CORRIGENDUM No. 4 DATED 29.08.2025

TENDER No.

BNPM/OTE/150/2025-26 dated 14.07.2025

1.0 ADDITION TO TENDER

BANK NOTE PAPER MILL INDIA PRIVATE LIMITED MYSORE-570003			
SIGNATURE		DATE	
PREPARED BY	N GUPTA	18/02/2021	
CHECKED BY	MOC : Cast Steel		Bale Plucker Floor Movement Ball screw
APPROVED BY	DRG.NO:BNPM/PP/34/2020-21

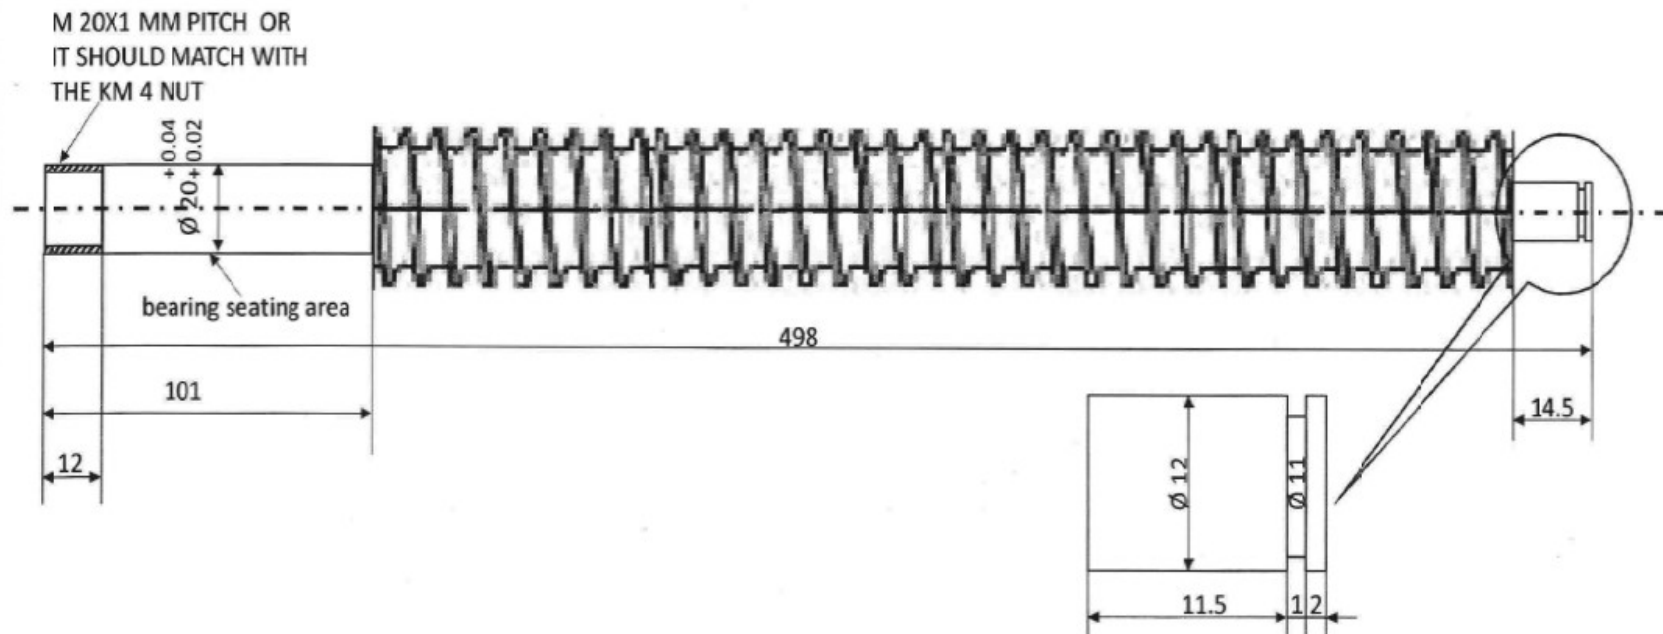
S. No	Tender clause	Existing	To be read as
1	Page No.39, Section VII - Technical Specifications	NIL	<ul style="list-style-type: none">• Overall Length of Ball Screw: 498.00 MM + 15 MM (Tolerance)• Threaded length on the ball screw: 382 mm.• End machining will be done at BNPM, Mysore only.• Enclosed drawing No. BNPM / DRG /034/ 2020-21
